RECOMMENDATION REPORT

City Planning Commission

LOCATION: 1515 South Veteran Avenue (1505, 1507, 1509, 1511, 1513, 1517, 1519, 1521, and 1523 South Veteran Avenue)

Case No.: CPC-2022-7045-CU3-DB-DRB-SPPC-HCA
CEQA No.: ENV-2022-7046-CE

SOUTH EAST ELEVATION
 3/16" = 1'-0"

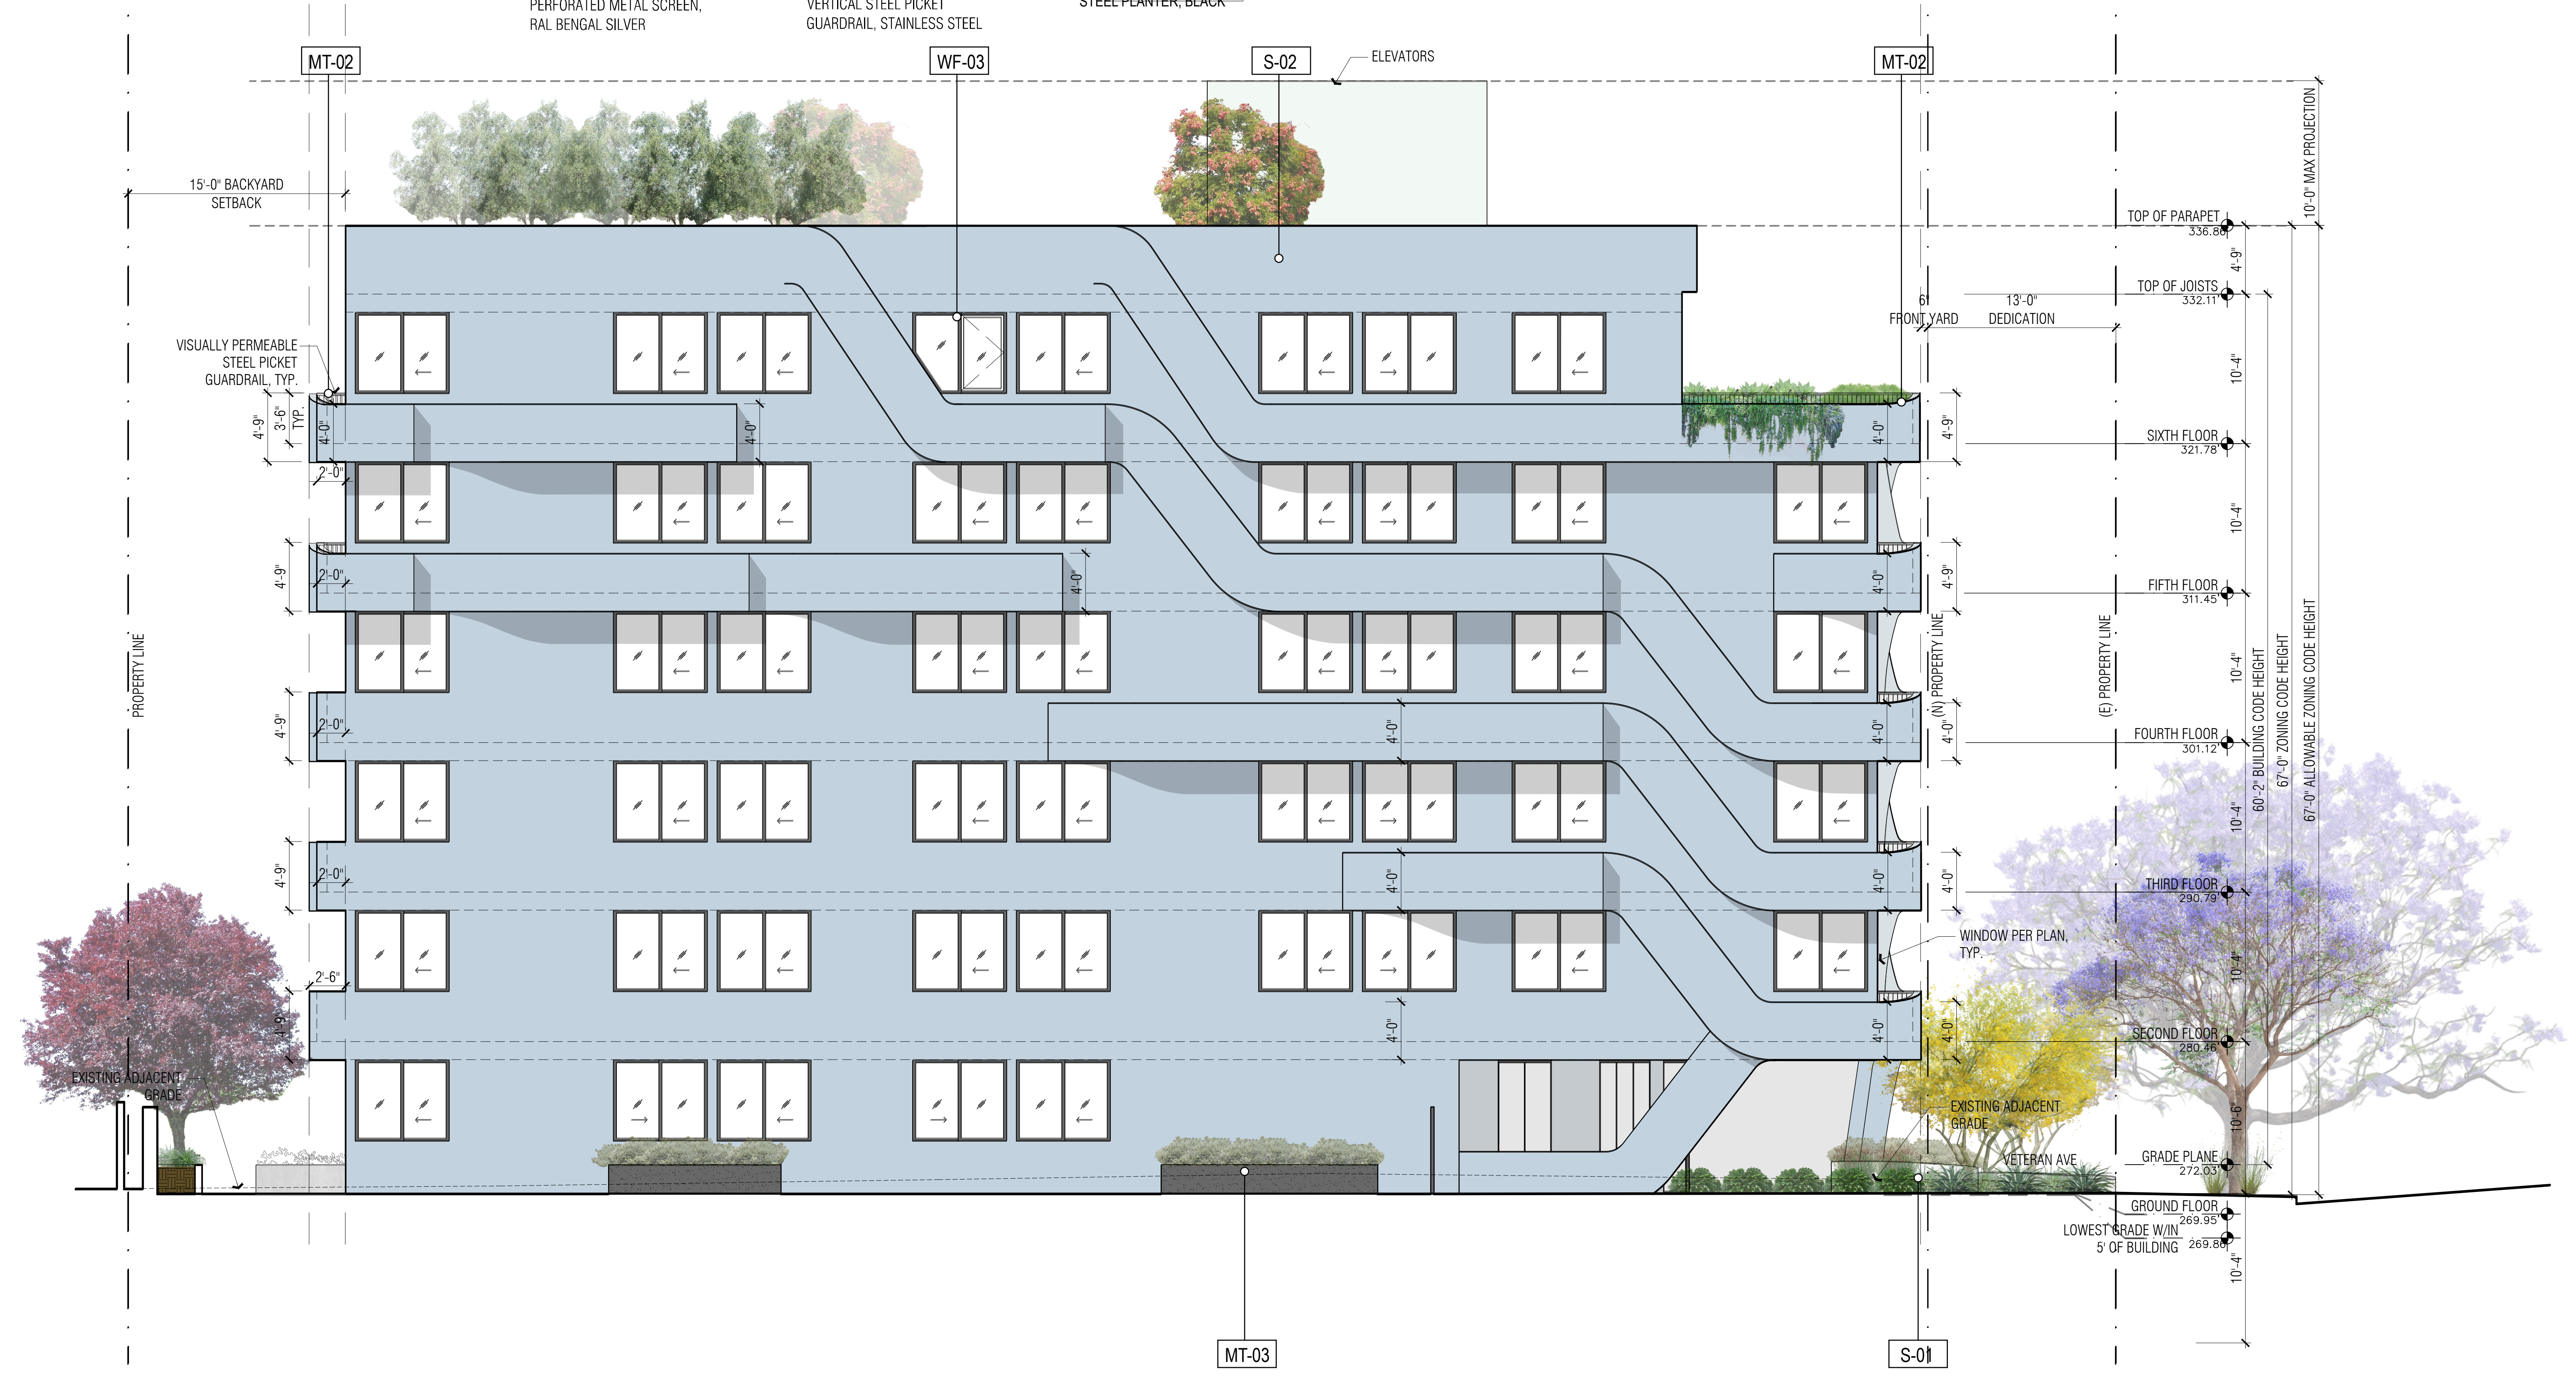
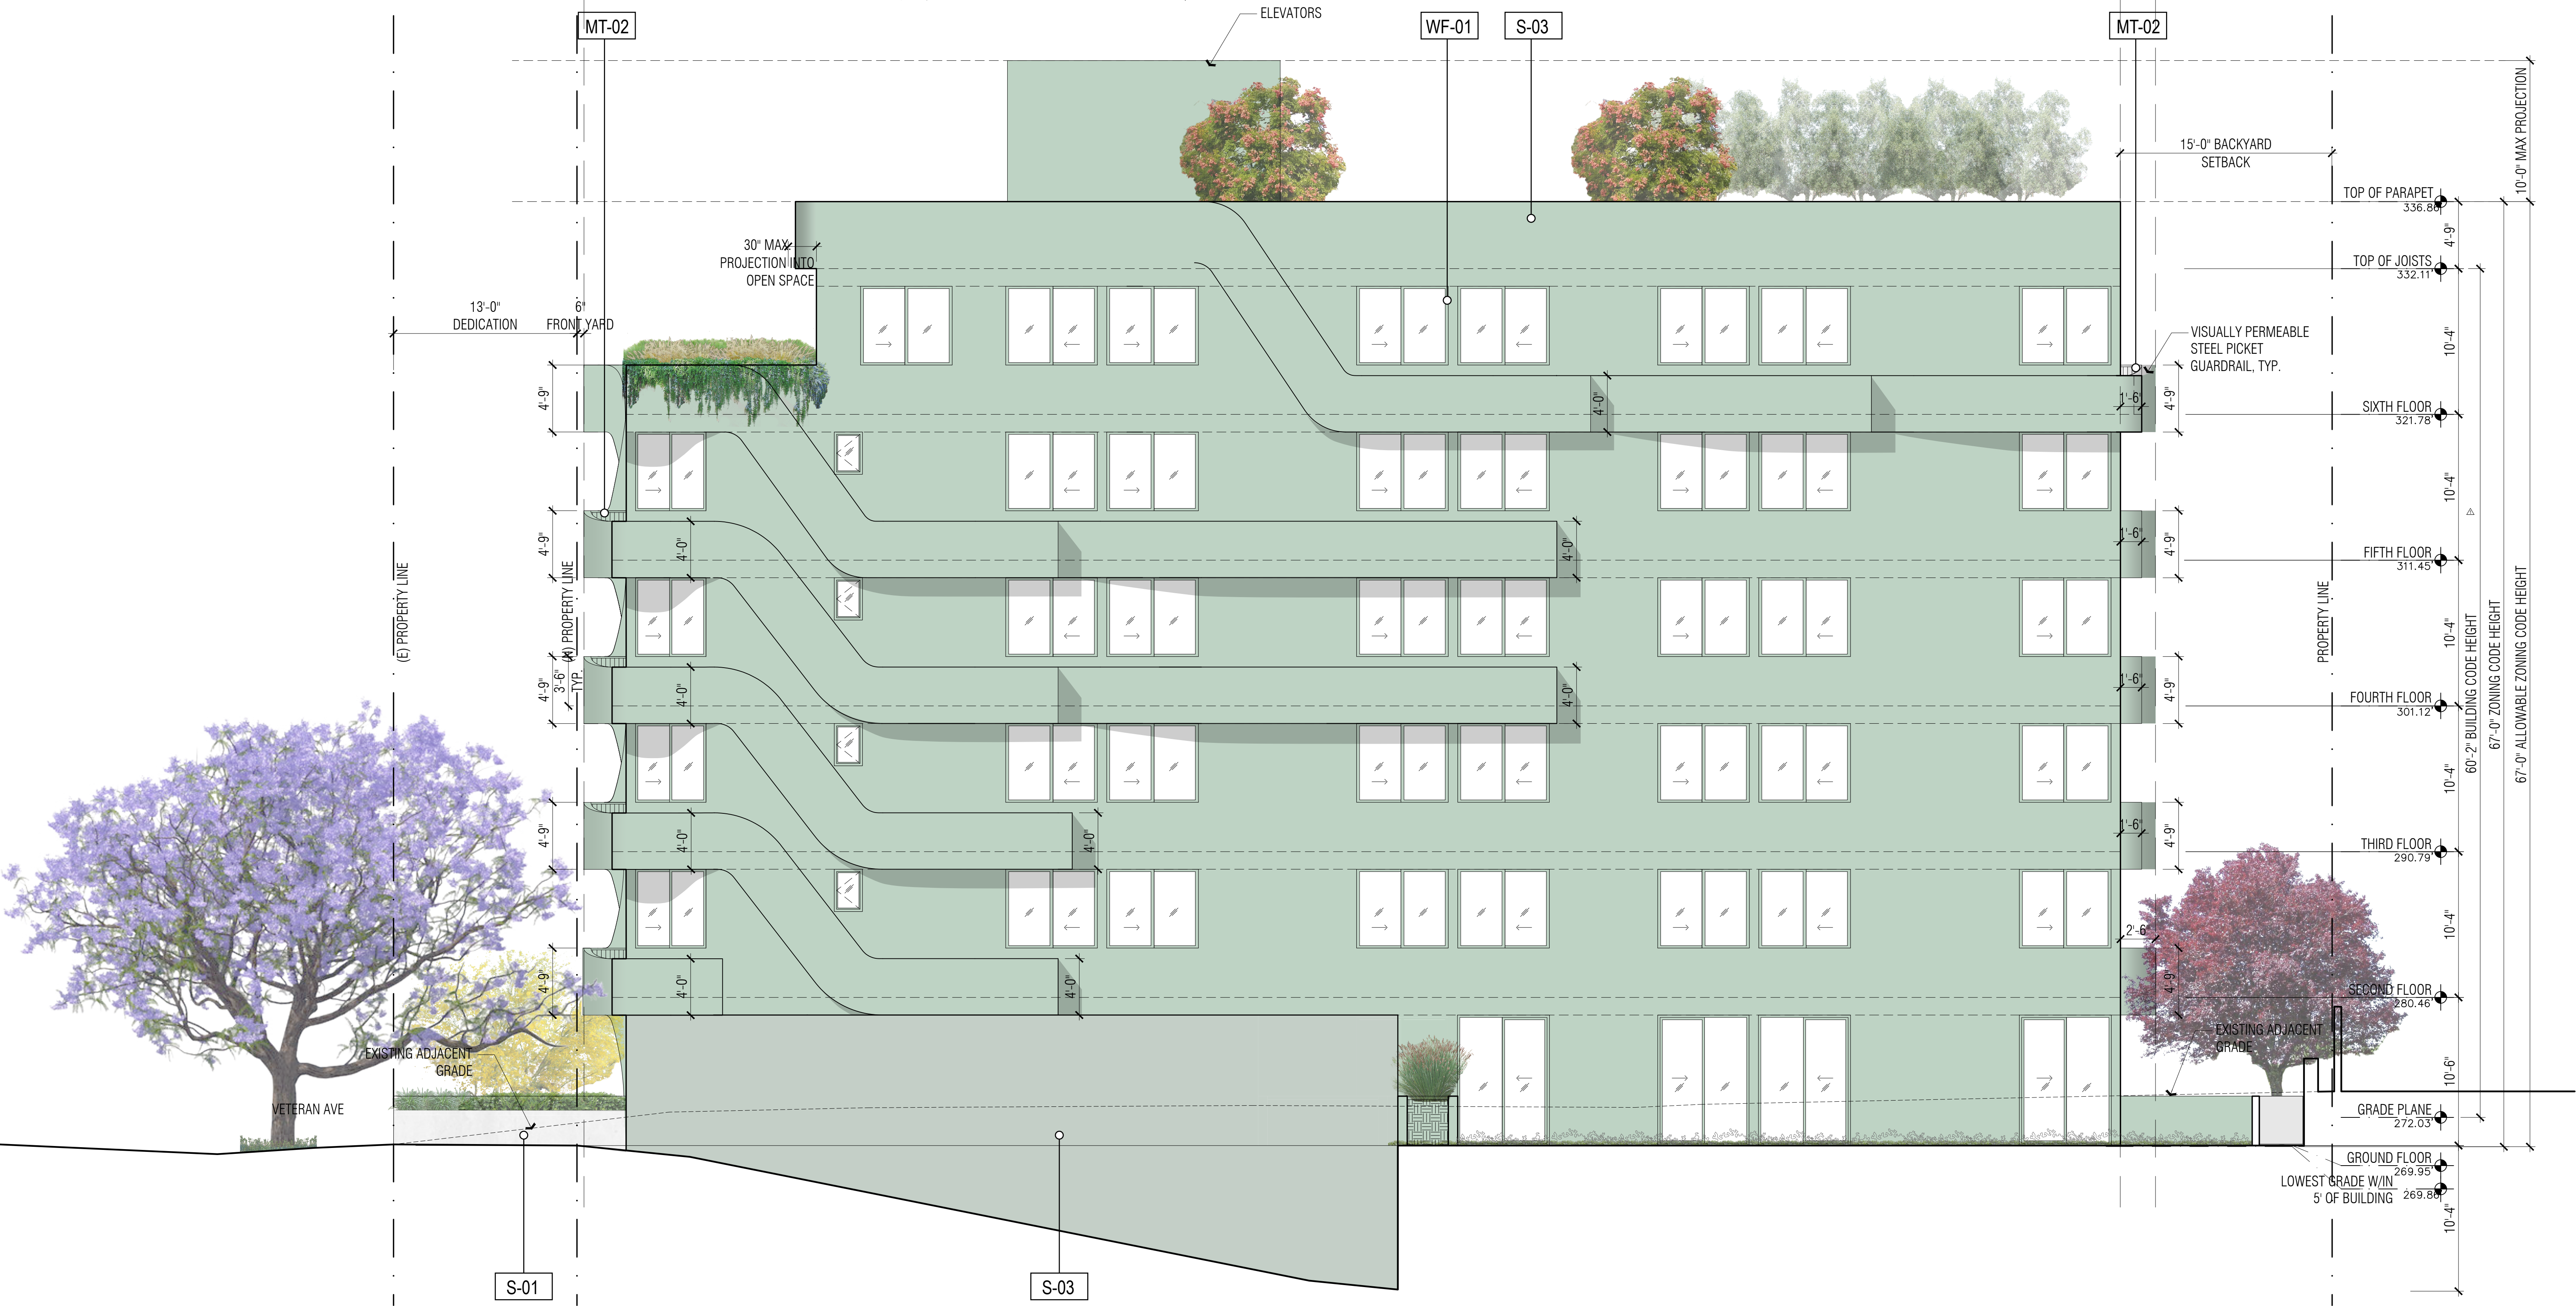
- Really difficult to understand from the elevations how or where the perforated metal is used on the upper floors above the courtyards; if used on part of the back wall of the courtyards, the plans don't seem to be depict this condition of part solid, stucco wall and part perforated metal.

- The banding elements across the frontage add enough interest and the arbitrary changes in color end up as a distracting element; would be a better building with just a single stucco color.

The applicant was generally responsive to the comments and revised the plans to address those related to the main entrance, courtyard, transformer, and artificial turf. The applicant provided written clarification on issues raised about the amount of automobile parking spaces, type of housing, cantilevered building corner over the driveway lanes, and trash bins. The applicant also confirmed that they have met with LADBS and Fire Department regarding comments on the side yard openings, access and ingress/egress, and trash chutes and that the proposed project will comply with their requirements. Finally, the applicant clarified that building permits for the proposed project was submitted to LADBS prior to 2023 and is therefore exempt from solar requirements pursuant to the 2019 Building Energy Efficiency Standards.
